Minutes of Pre-bid Meeting

Name of the Package: Construction of Custom House Chattogram (CCH) and relevant structures

Tender Package No.: WD-03

Tender Ref. No: WD-03 Date: January 18, 2026

DRAWING TITLE
CUSTOMS HOUSE MASTERPLAN (PLANTATION)

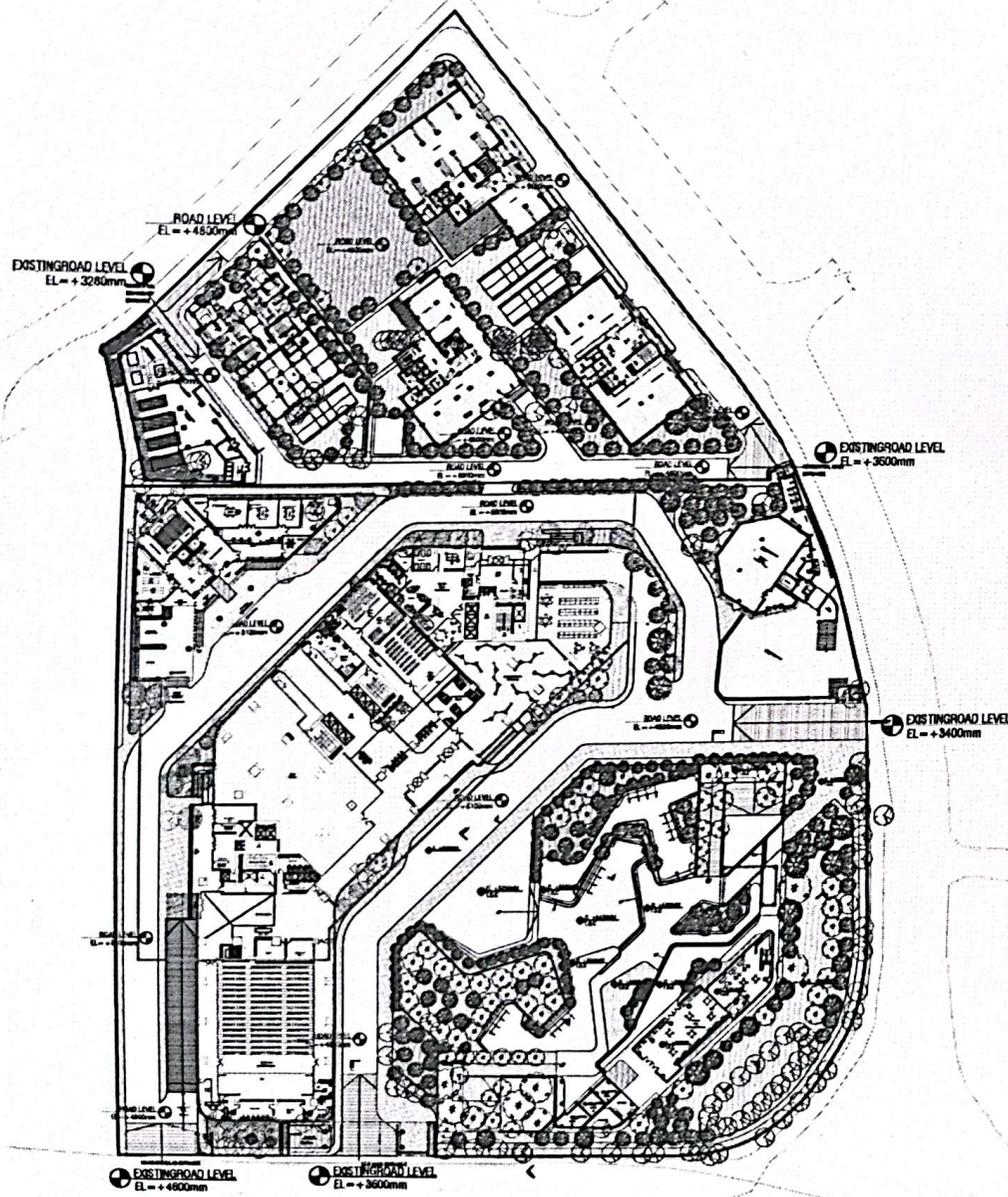
- (a) Annexure-1: Attendance Sheet.
- (b) Annexure-2: The Manufacturer's Authorization Form (MAF),
- (c) Annexure-3: Part (1 of 5) Custom House, Lab & Warehouse Construction Works BOQ, Annexure 3.0 Part 1. Part (3 of 5), General & Utilities, Fire Protection System, Fire Detection & Alarm System & Mechanical System BOQ, Annexure 3.0 Part 2.
- (d) Annexure-4: WD-3 Custom House – BOQ Architectural Item-30 Stair railing (F.I bar 38mm x 6mm)
- (e) Annexure-5: Tree Plantation, Landscape and Land Development, BoQ item #23
